Subject: Notification of Class 1 Permit Modification to the Waste Isolation Pilot Plant  
Hazardous Waste Facility Permit Number: NM4890139088-TSDF

**Class 1 Permit Modification Notifications**

**Waste Isolation Pilot Plant**

**WIPP Permit Number - NM4890139088-TSDF**

**Figure A1-8a**  
**TRUPACT-II Shipping Container for CH Transuranic Mixed Waste (Schematic)**

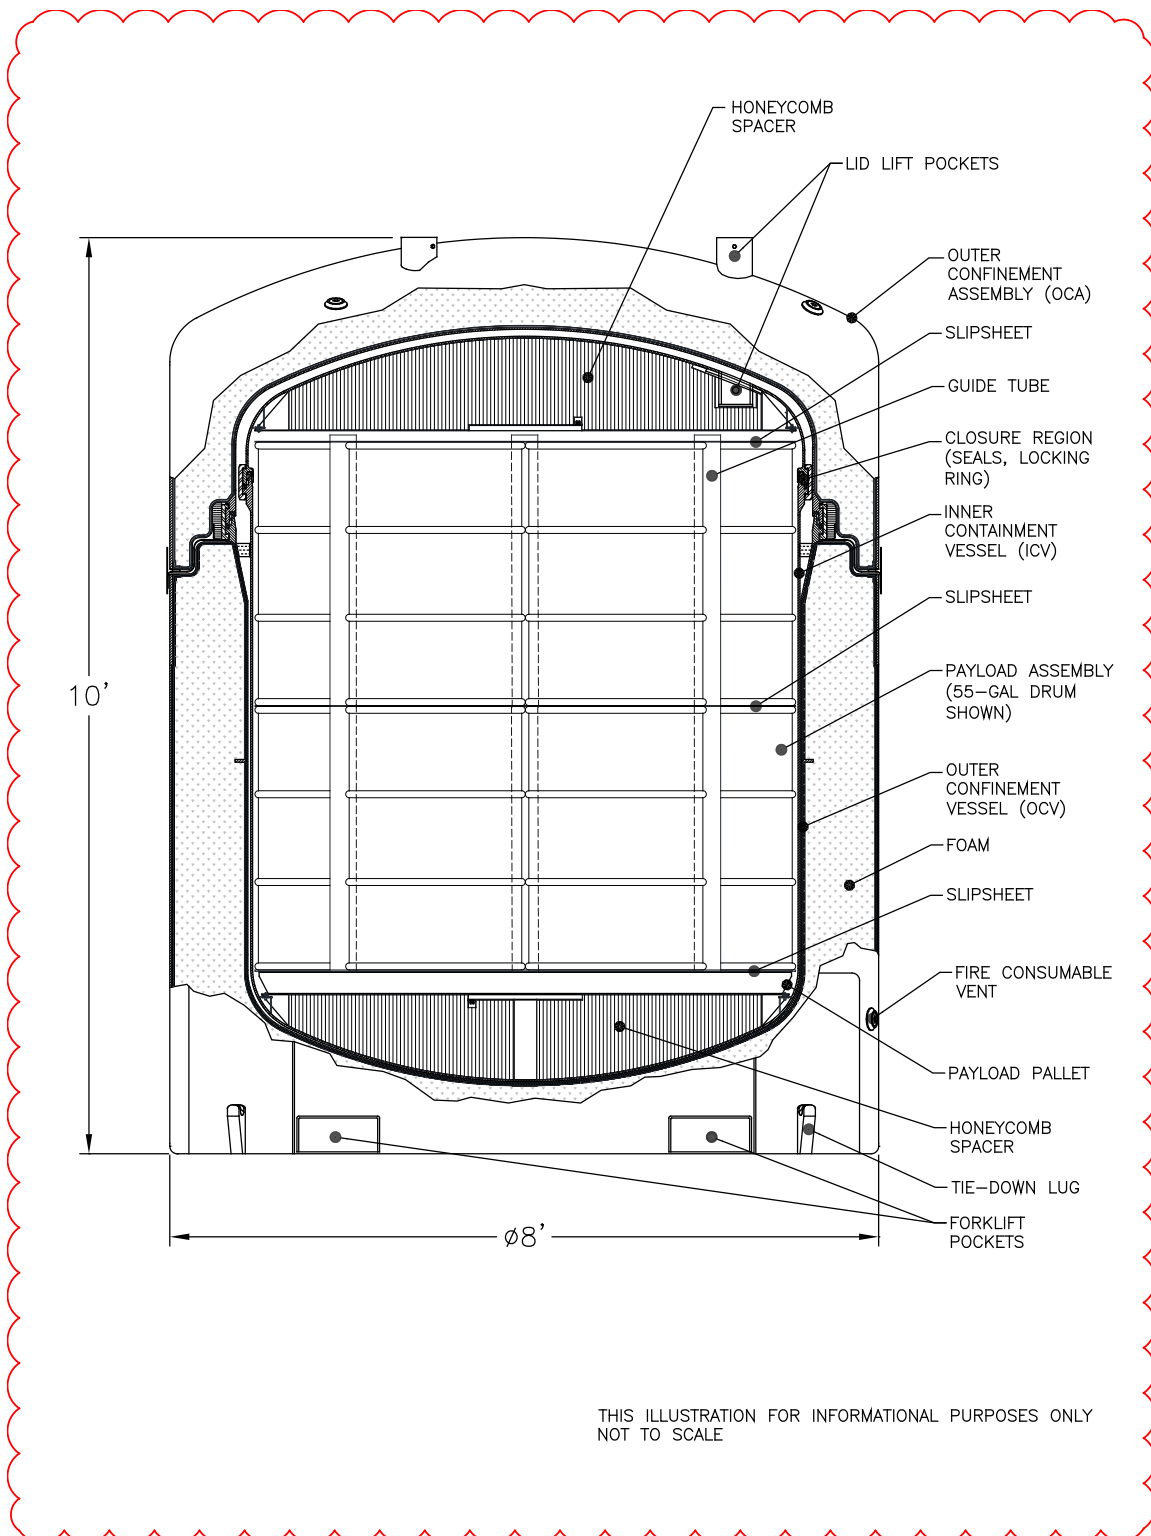
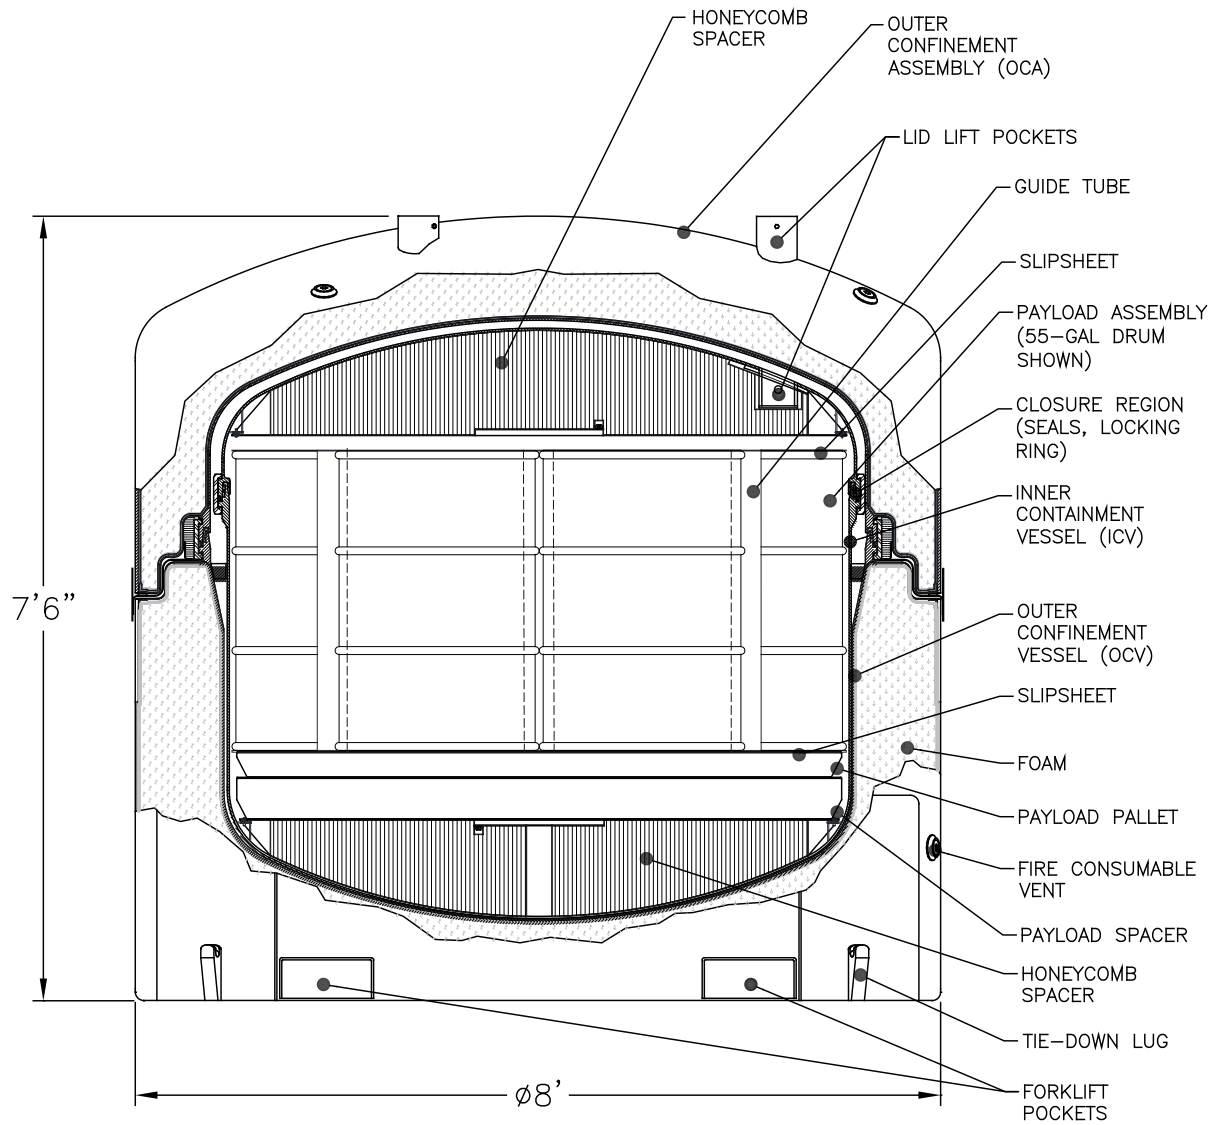
The figures for the TRUPACT-II (Figure A1-8a) and HalfPACT (Figure A1-8b) are being replaced with more legible and updated drawings. The changes to Figure A1-8a include changing "Protective Structure/Impact Limiter" to "OUTER CONFINEMENT ASSEMBLY (OCA)," "Honeycomb Dunnage" to "HONEYCOMB SPACER," "Payload (55-gallon Drums or Standard Waste Boxes)" to "PAYLOAD ASSEMBLY (55-GAL DRUM SHOWN)," "Locking ring (Typ)" and "Seals (Typ)" to "CLOSURE REGION (SEALS, LOCKING RING)," "Outer Containment Vessel (OCV)" to "OUTER CONFINEMENT VESSEL (OCV)," "Drum Pallet" to "PAYLOAD PALLET," "Honeycomb Dunnage" to "HONEYCOMB SPACER." This modification adds "LID LIFT POCKETS," "GUIDE TUBE," "FIRE CONSUMABLE VENT," "TIE-DOWN LUG," "THIS ILLUSTRATION FOR INFORMATIONAL PURPOSES ONLY NOT TO SCALE" and "ø" before "8" to denote it is a diameter and not a length. The changes to Figure A1-8b include changing "Protective Stainless Steel Skin 3/8" Thick" to "OUTER CONFINEMENT ASSEMBLY (OCA)" and "Honeycomb Impact Limiter" to "HONEYCOMB SPACER," "Inner Containment Vessel 72.60" I.D. 1/4" Thick" to "INNER CONTAINMENT VESSEL (ICV)," "Outer Containment Vessel 73.60" I.D. 1/4" Thick" to "OUTER CONFINEMENT VESSEL (OCV)," "Foam 10" Thick" to "FOAM" and "Honeycomb Impact Limiter" to "HONEYCOMB SPACER." This modification deletes "Lytherm insulation 1/4" Thick." This modification adds "LID LIFT POCKETS," "GUIDE TUBE," "SLIPSHEET," "PAYLOAD ASSEMBLY (55-GAL DRUM SHOWN)," "CLOSURE REGION (SEALS, LOCKING RING)," "SLIPSHEET," "PAYLOAD PALLET," "FIRE CONSUMABLE VENT," "PAYLOAD SPACER," "TIE-DOWN LUG," "THIS ILLUSTRATION FOR INFORMATIONAL PURPOSES ONLY NOT TO SCALE" and "ø" before "8" to denote it is a diameter and not a length. Also, the remaining labels were capitalized for clarity.

**Figure A1-8b**  
**Typical HalfPACT Shipping Container for CH Transuranic Mixed Waste (Schematic)**

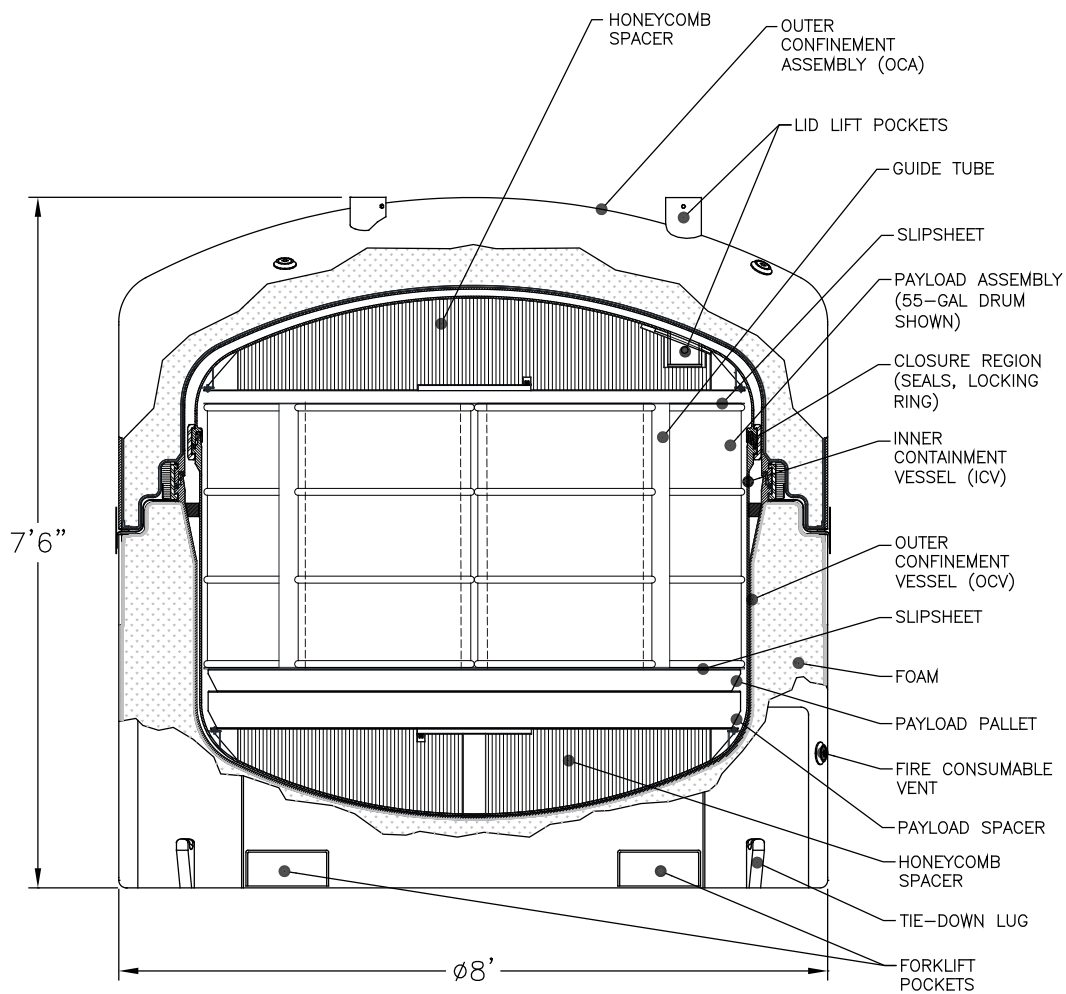
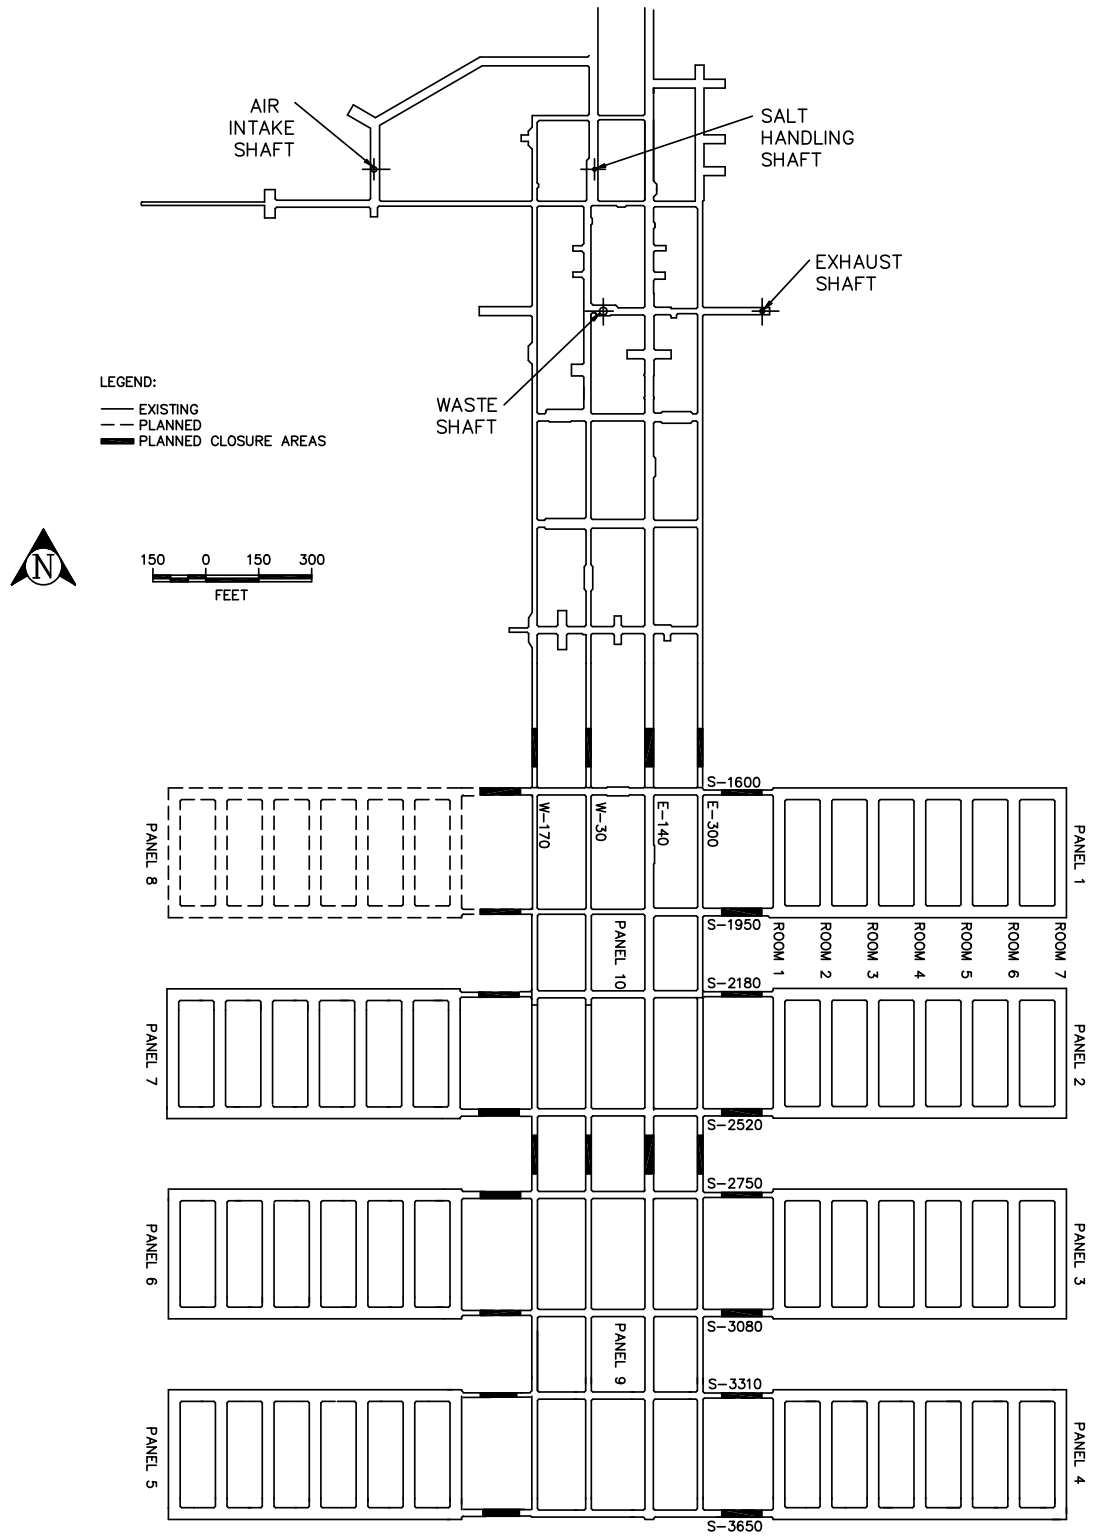
An editorial change in the diameter of the HalfPACT from “7.8 ft” to “8 ft” is required to correct a typographical error and make it consistent with the diameter of the TRUPACT-II and Figure A1-8b. Also, the language related to the ICV is being made consistent throughout the Permit. This change will clarify the frequent reference to an “inner vessel.”

**Figure A2-1**  
**Repository Horizon**

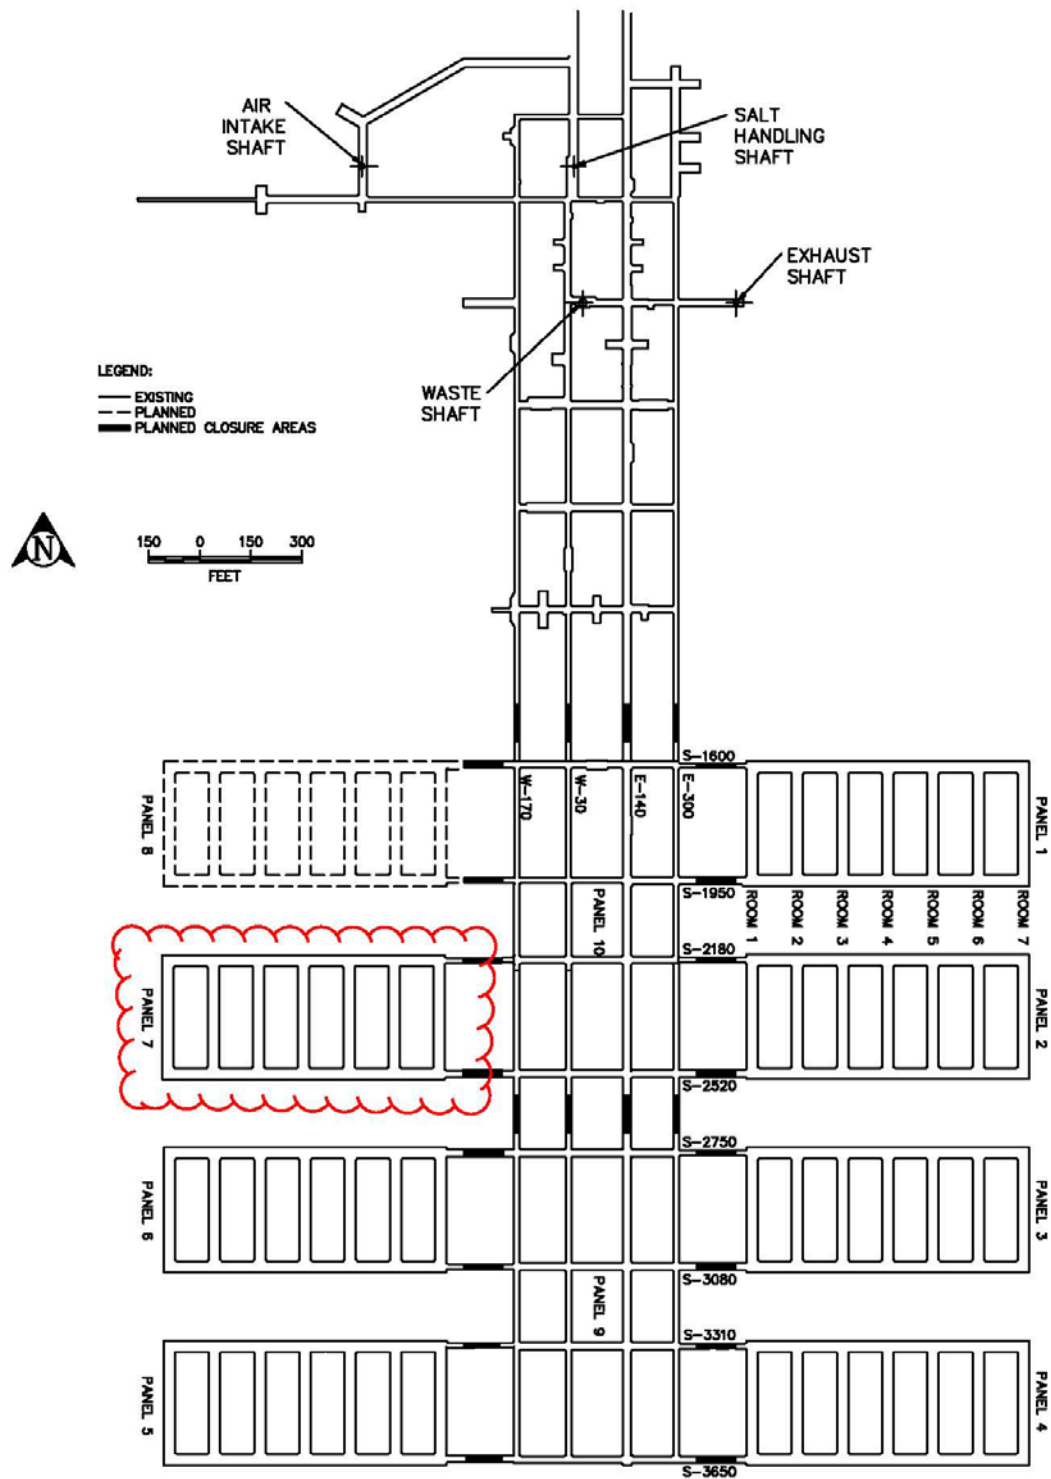
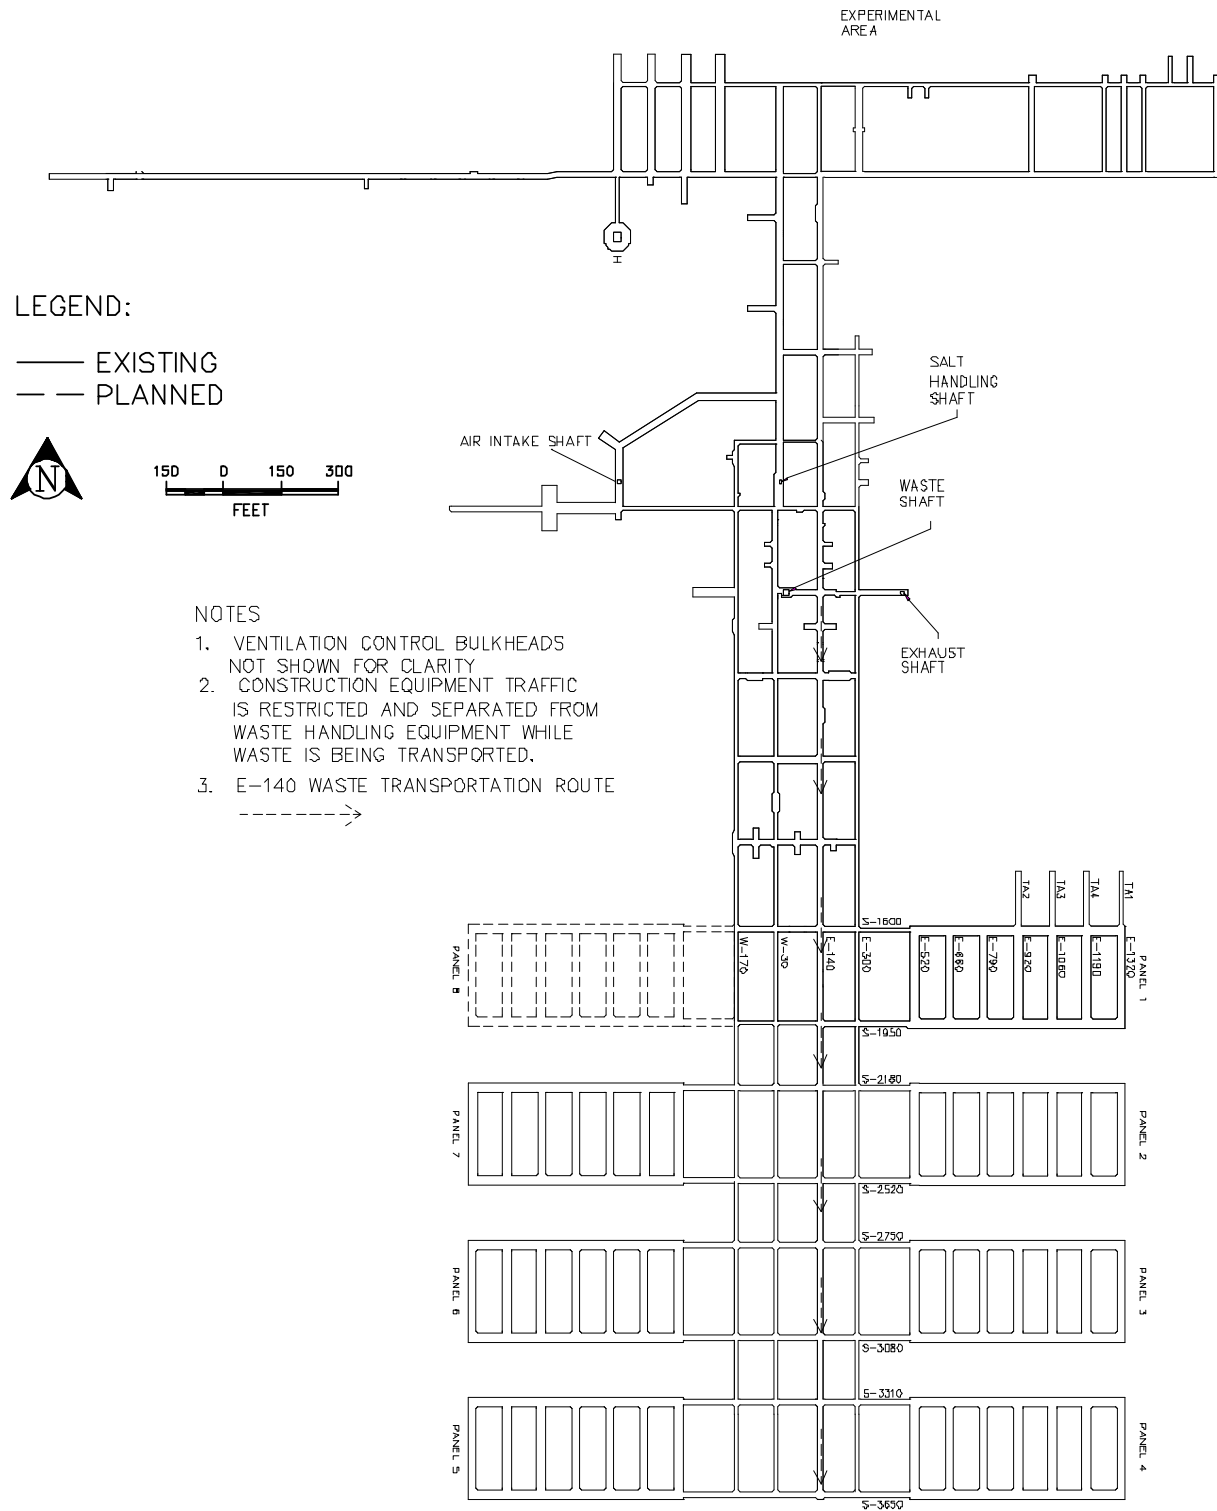
This modification revises Permit Attachment K, Table K-4 and Permit figures A2-1, A4-4, A4-4a, B3-2, D-3, D-5, D-9, G-1, G-6, G2-1, and N-1 to indicate that Panel 7 has been approved by the NMED. The text “SWMU 013i Underground HWDU – Panel 7” is being added to Attachment K, Table K-4. The figures were updated by changing Panel 7 status from “planned” to “existing” hazardous waste disposal unit (HWDU). This is done by changing dashed lines to solid lines or by adding Panel 7 to respective figures. Additional editorial changes were made to some figures which included the following: added legend, north arrow, and scale to Figures A4-4 and A4-4a; added Panel legend (for existing and planned Panels) and moved north arrow and scale to top of Figure D-5; added borehole markers for boreholes H-16 and WIPP-19 and moved H-16 borehole caption to the right on Figure G-6. Also see the Table of Changes and the “clouded” figures in Appendix C of this PMN for a description of these changes.

On July 16, 2013, the Permittees were notified by the NMED that Panel 7 had been constructed in compliance with the requirements of the Permit. Panel 7 is now available for waste emplacement. Figures A2-1, A4-4, A4-4a, B3-2, D-3, D-5, D-9, G-1, G-6, G2-1 and N-1 have been revised to show that Panel 7 is now authorized for waste disposal. The change removes the “dashed” lines and replaces them with “solid” lines in order to change the designation from “planned” HWDU to “existing” HWDU.
